P-4805
S1241
16760

SYMBOL OF QUALITY AN ISO 9002 COMPANY	JINDAL ALUMINIUM LTD. BANGALORE-560073 (INDIA)	NAME		DATE
		DRAWN	RAGHAVENDRA	11-08-2004
1. ALL DIMENSIONS ARE IN mm. 2. ROUND OFF ALL SHARP CORNERS WITH 0.40 mm. 3. TOLERANCES WILL BE AS PER BA:1474-1987 UNLESS OTHERWISE SPECIFIED		CHECKED		
		APPROVED		
PARTY'S NAME VENUKANTH ENGINEERS, CHENNAI		SCALE		5:1
		AREA mm ²		78.54
PARTY'S DRAWING No. AS PER SPECIFICATION		PERIMETER mm.		70.76
		WEIGHT kg/m		0.212
ALLOY & TEMPER 6063 T6		DRAWING No.		P-4805
		SECTION No.		-
DESCRIPTION UNEQUAL ANGLE		S1241		S1241-ISSUE-2
		16760		16760

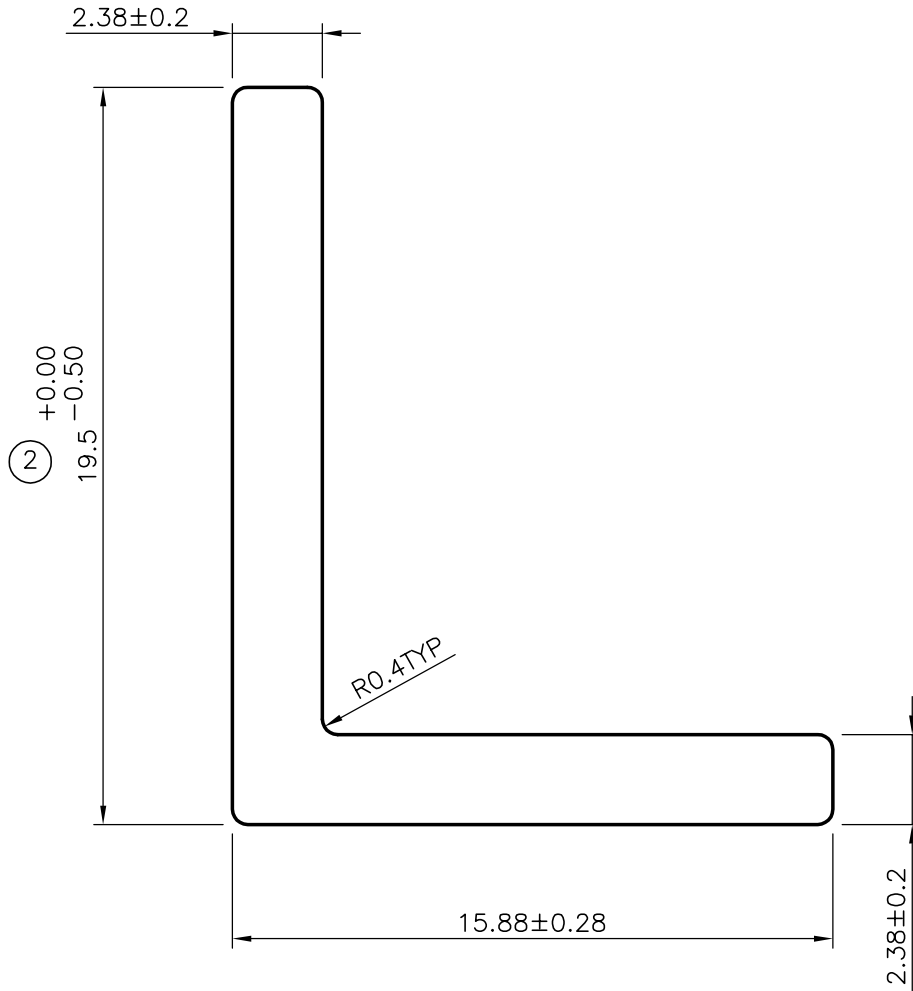
ISSUE-2 TOLERANCE CHANGED FROM 19.5±0.30 TO 19.50 ^{+0.00}/_{-0.50}
